**Notification # 20240923000.0
Marking Standardization for Select Devices
Information Only**

Date: September 23, 2024
To: MOUSER PCN

Notification Number:	20240923000.0		Notification Date:	September 23, 2024	
Title:	Marking Standardization for Select Devices				
Customer Contact:	Change Management team		Dept:	Quality Services	
Change Type:					
<input type="checkbox"/> Assembly Site	<input type="checkbox"/> Design	Wafer Bump Material			
<input type="checkbox"/> Assembly Process	<input type="checkbox"/> Data Sheet	Wafer Bump Process			
<input type="checkbox"/> Assembly Materials	<input type="checkbox"/> Part number change	Wafer Fab Site			
<input type="checkbox"/> Mechanical Specification	<input type="checkbox"/> Test Site	Wafer Fab Materials			
<input checked="" type="checkbox"/> Packing/Shipping/Labeling	<input type="checkbox"/> Test Process	Wafer Fab Process			
Notification Details					
Description of Change:					
This notice is to communicate an update in the device symbolization format for the devices in the product affected selection as follows:

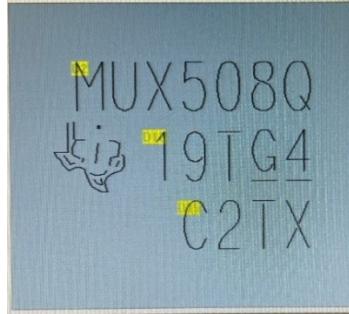
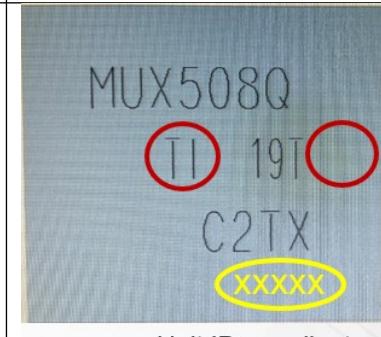
Current	New		
**ECAT		Include Value	Remove		
TI Bug		Include	Replace with "TI" text		
Mold Unit ID		None	With		
Example			 xxxxx – Unit ID coordinate		
Reason for Change:					
Improved internal traceability					
Anticipated impact on Fit, Form, Function, Quality or Reliability (positive / negative):					
Device marking change only					
Changes to product identification resulting from this notification:					
Device marking change only. No change to pack labels					
Product Affected:					
TPS92642QPWPRQ1		TPS92643QPWPRQ1
